## ADDENDUM #5

October 16, 2024

RE: Solicitation Addendum #5 to RFP #25-01/KVMH Emergency Department Renovation, Phase 3

**WALL DETAIL**  
 SCALE:  $1\frac{1}{2}'' = 1'-0''$

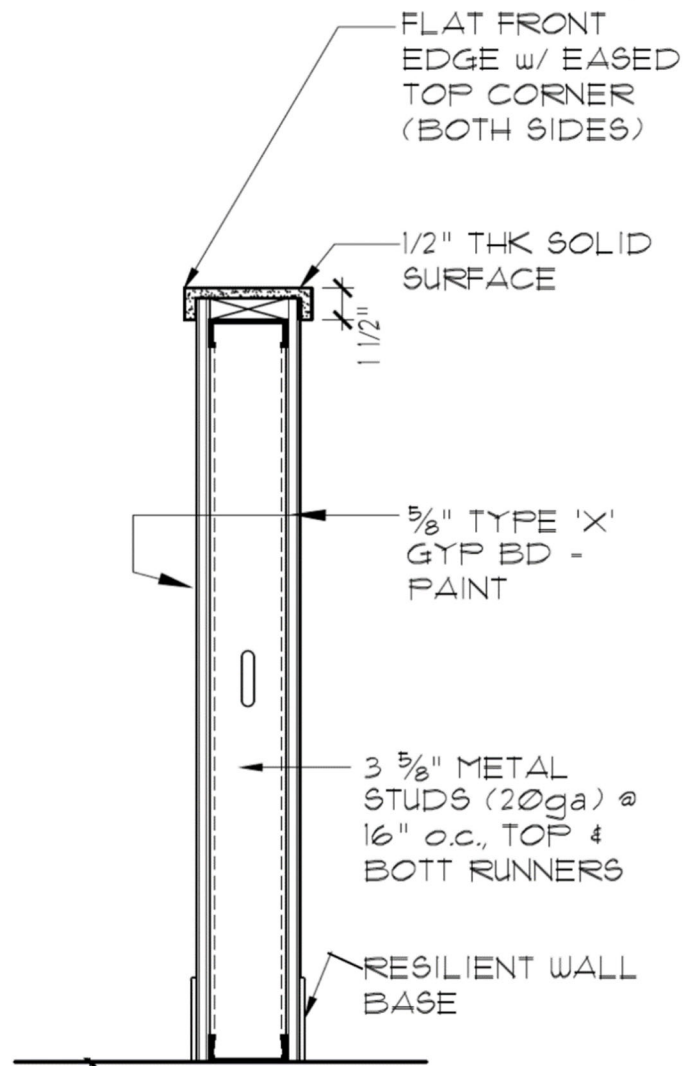
2. Q: Which wall type does the low wall in the south side of the Doctor's Charting room fall under?

A: See attached for detail.

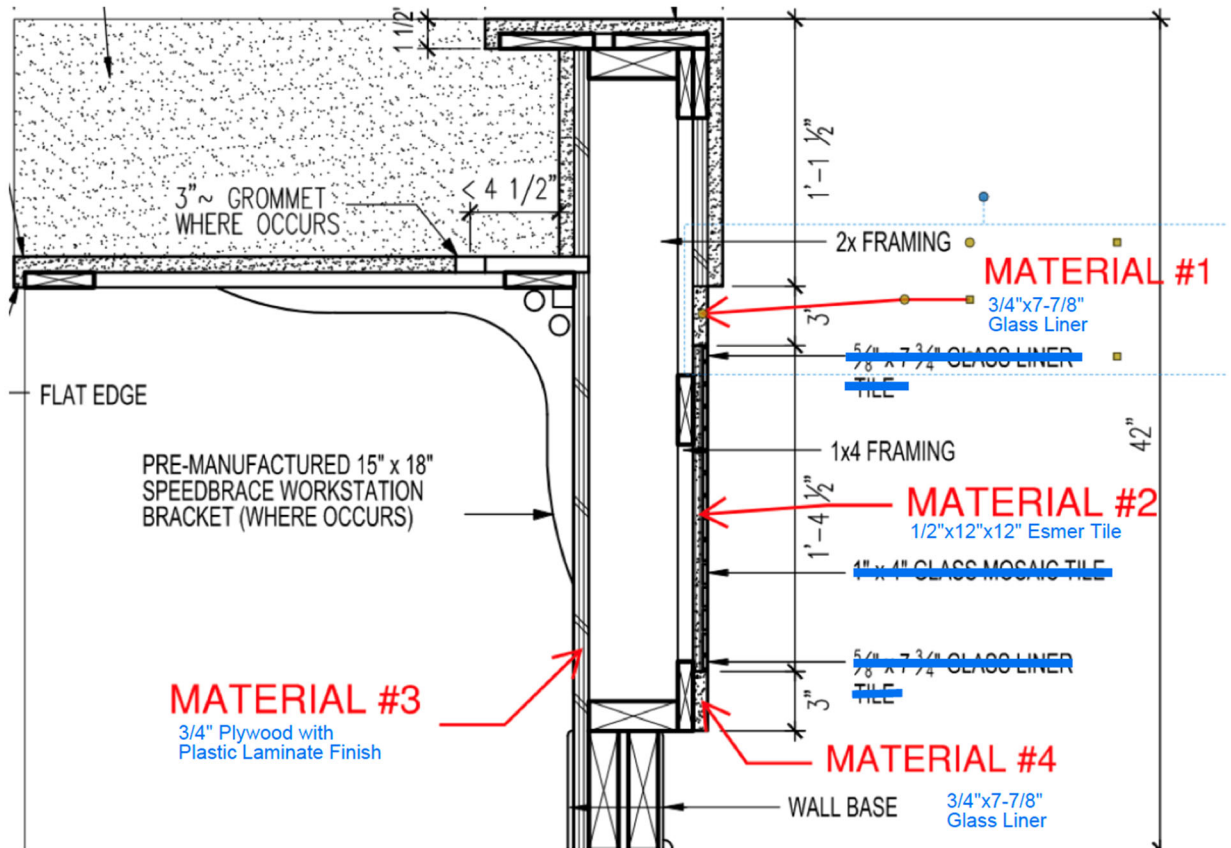
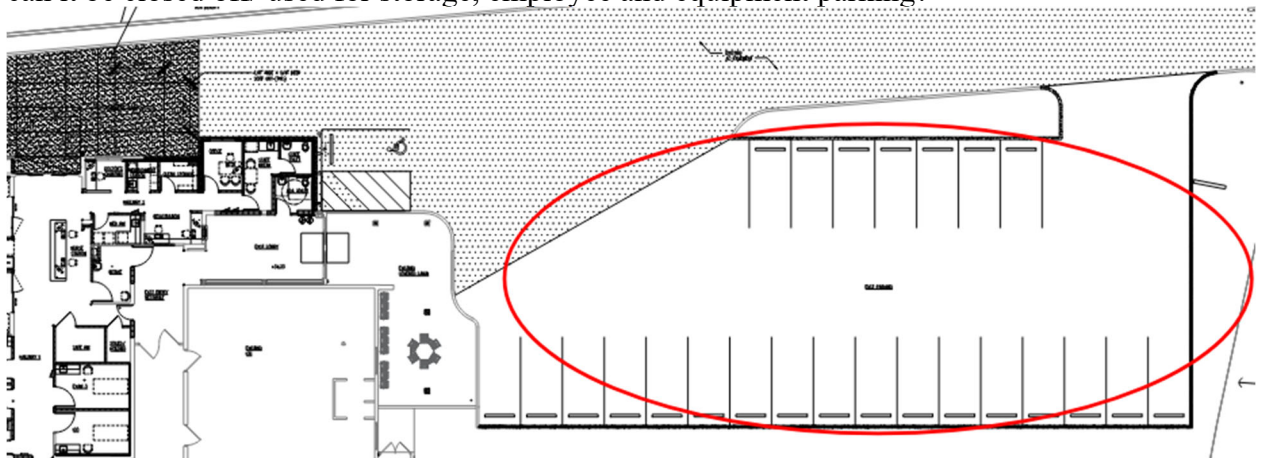
3. Q: In Detail 3/A012, certain materials related to the Nurse's Station are not specified. Please provide information regarding the materials indicated in the image below.

A: See below.

**IDEAL 2000 SERIES MODEL D 18X18X72"**

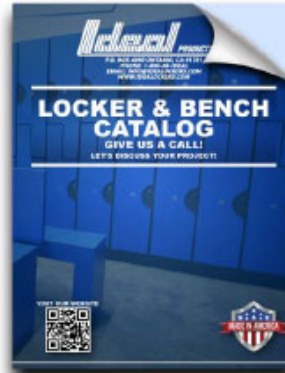
6. Q: On page 10C-1 in the specifications, the lockers are requested to be Model D1 by Hollman. Are subs able to provide equal products from different locker suppliers? See attached PDF below for example substitute. (Page 6)

A: Equal locker products are acceptable for use.

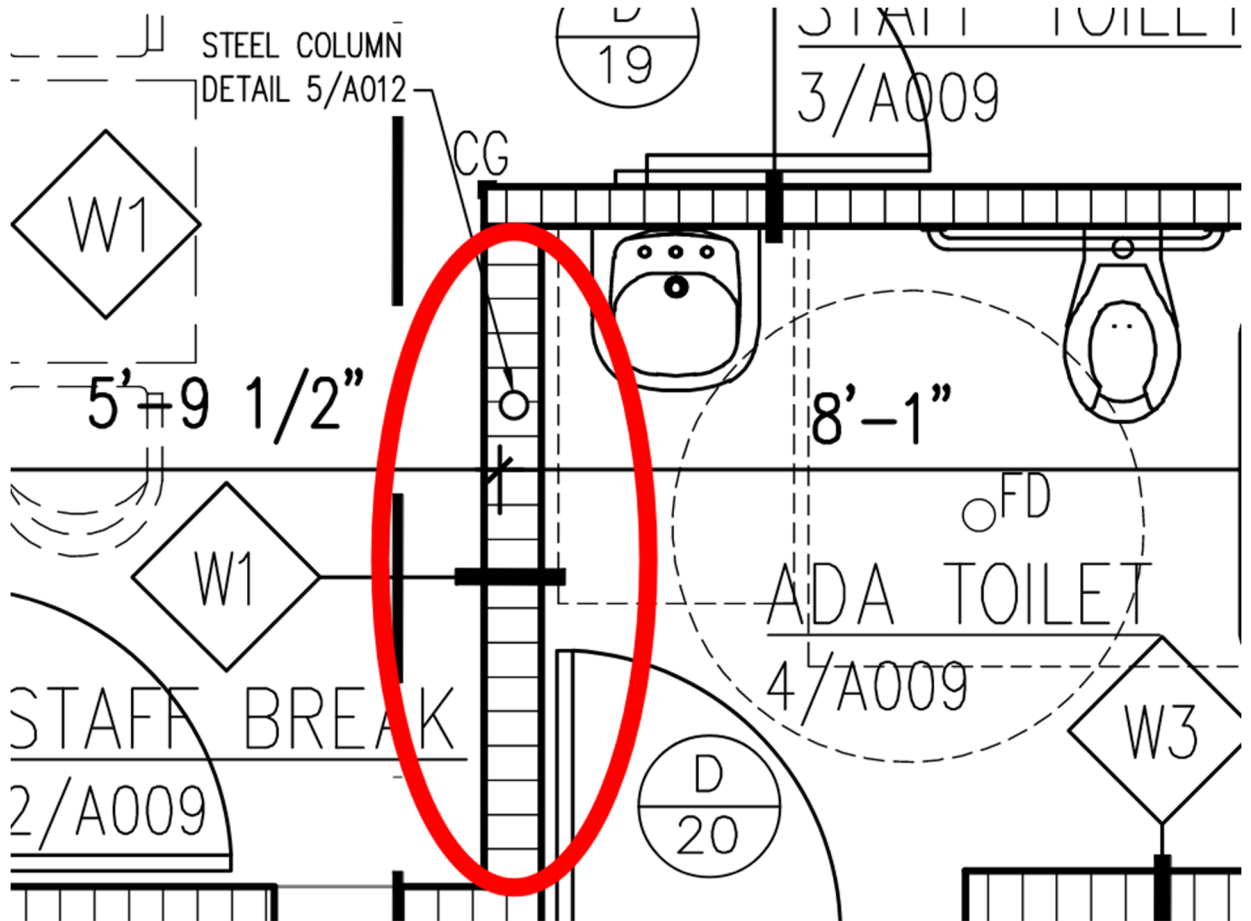
10. Q: Sheet A003 calls the wall separating the ADA toilet and Staff break rooms as Wall Type #1. Detail 5/A012 calls for 6" metal stud framing rather than 3 5/8". Please verify the width of the metal stud framing and the finish dimensions for the wall. Please also provide information on the placement of the steel column in this wall.

A: The metal stud at this wall is to be 6" to accommodate fire-proofing applied to steel post. 7'-10" from finish to finish within the ADA Toilet is to be held.

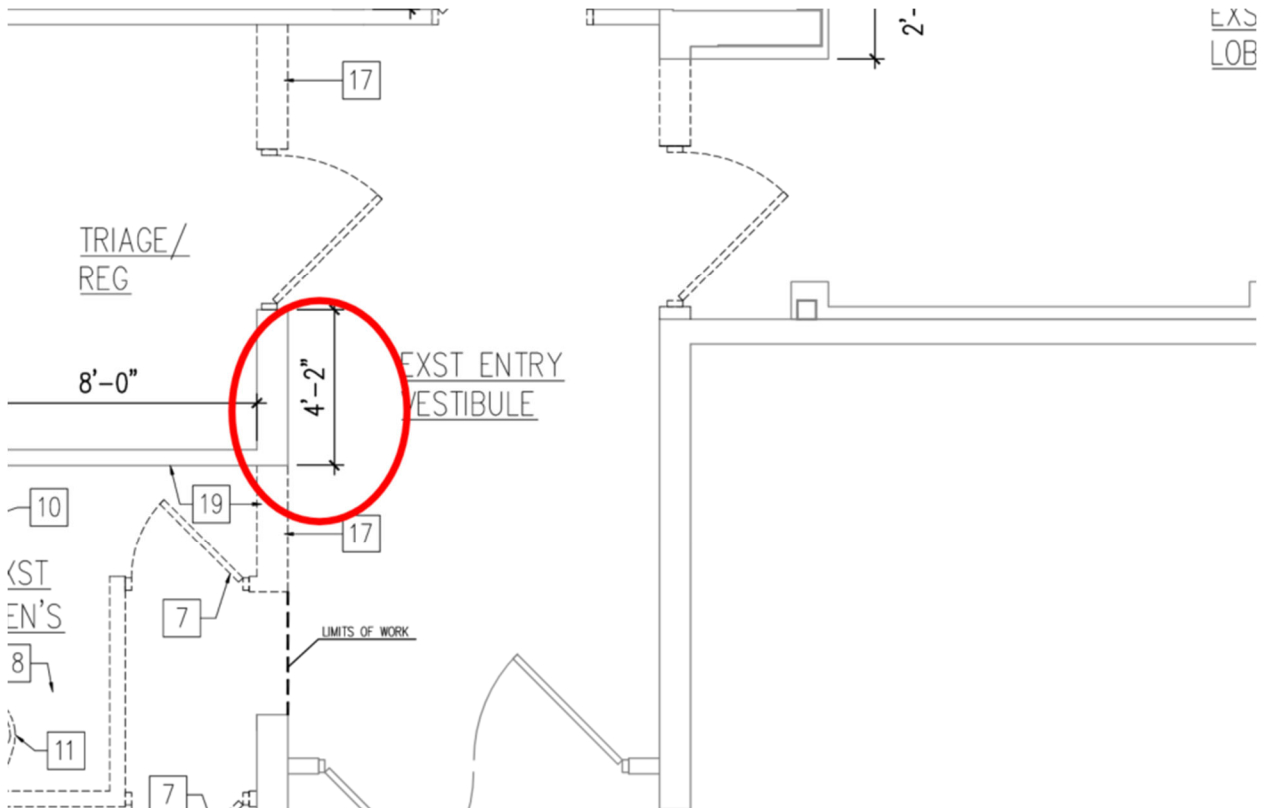
12. Q: On sheet A001 and M006, there is no mention of the water fountain found in the existing entry vestibule. Please clarify what should be done with the water fountain.

A: Existing water fountain is to remain.
